CITY OF SARATOGA, CALIFORNIA

ADDENDUM NO. 1

CORPORATION YARD BUILDING SOLAR PROJECT

CORPORATION YARD PROPOSED SINGLE LINE DIAGRAM FOR ADDITION OF A PV SYSTEM

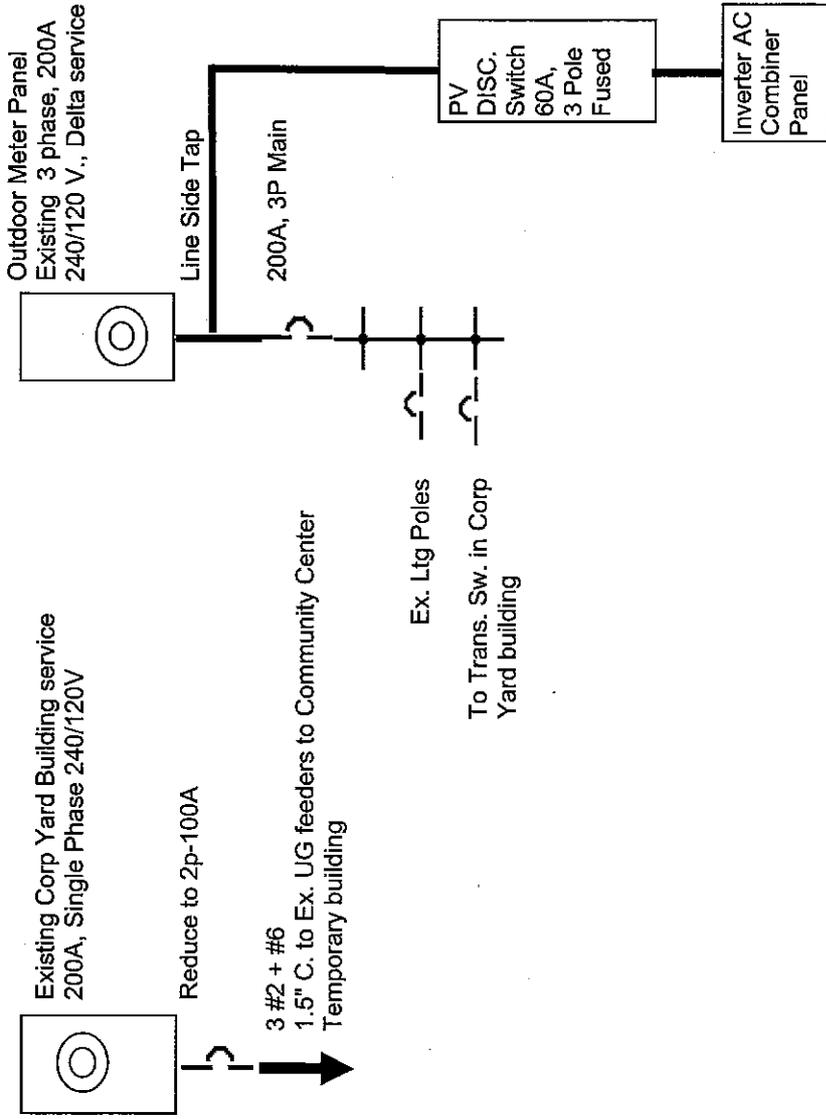
Question No. 2: Transfer switch: what is the intent of the city? Are you trying to connect the solar to a different meter with a manual transfer switch?

Answer: The transfer switch is part of the existing building wiring for the Corp Yard building and is connected to the existing service panel in the meter closet. That existing service panel will be disconnected from the Corp Yard building, its main breaker reduced to 100 A. and connected to the Community Center temporary building's feeder conductors. The Corp Yard will be fed from a 2P-100A breaker in the 3 phase panel. The line side of the Main breaker in the 3 phase panel will be tapped to conductors that are the line side of the PV disconnect switch. In effect, the Corp Yard building is only one of the loads fed by the 3 phase panel. Please refer to the attached Power Single Line drawing.
